PSB#062193
 Incorrectly Manufactured MS-22040
 June 21, 1992

Identification: All Vector container systems manufactured between April 22, 1993 and June 10, 1993

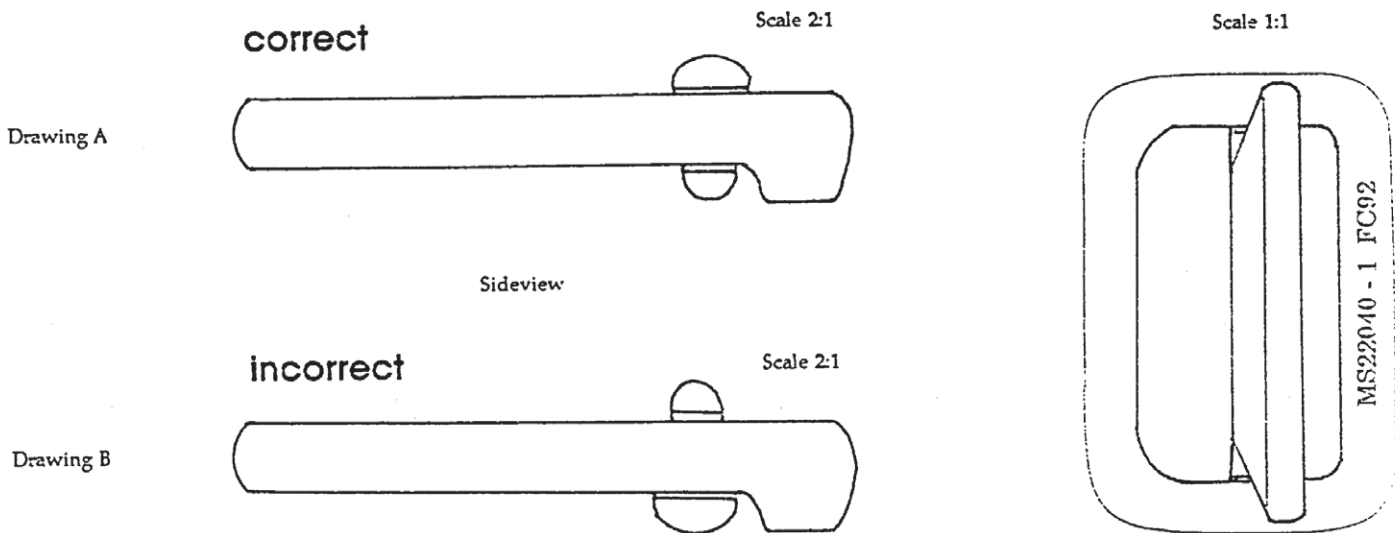
Background: One Vector container system has been discovered in the field with this incorrectly manufactured hardware. This is not life threatening, but may allow webbing slippage; thus resulting in an uncomfortable harness. Service Bulletin: This is a one-time inspection. Compare MS-22040 hardware against drawing A and B. If hardware is correct (drawing A), log bulletin compliance on data card. If hardware is incorrect (drawing B), notify Relative Workshop.

Where to check for this hardware: Leg straps (tandem and sport) and chest straps (tandem and tandem passenger harness).

Qualified Personnel: Senior or Master parachute rigger Compliance Date: At next reserve repack
